WE HAVE REVIEWED THE SITE AND GRADING PLAN FOR THE PROPOSED BUILDING TO BE CONSTRUCTED, AND HEREBY

REFER TO SCS DWG.: DETAIL I-1 MODIFIED. INFILTRATION TRENCH SITING AND GRADING PLAN

PINE HEIGHTS DRIVE **GOLDPARK HOMES - 217020** PINE VALLEY, VAUGHAN ONT.

AW AW 1:250 217020WSP01

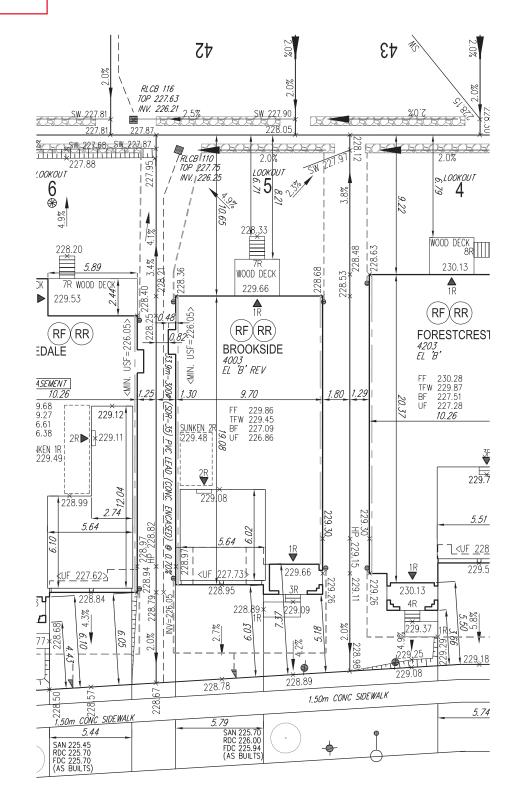
- The proposed grading and appurtenant drainage works comply with sound engineering principles. The proposed grading is in conformity with the grading plan
- approval for this subdivision and will not adversely affect adjacent lands. 3. The proposed building is compatible with the proposed grading.
- 4. The proposed water service curb stop is to be located in the grassed portion of the front yard.

The driveway conforms with the City of Vaughan By-Law 1-88
- as amended and is a minimum 1.0 metre clear of all street landscape catch basins
- 6. The proposed building is a minimum of 0.6 m side yard setback from a drainage swale
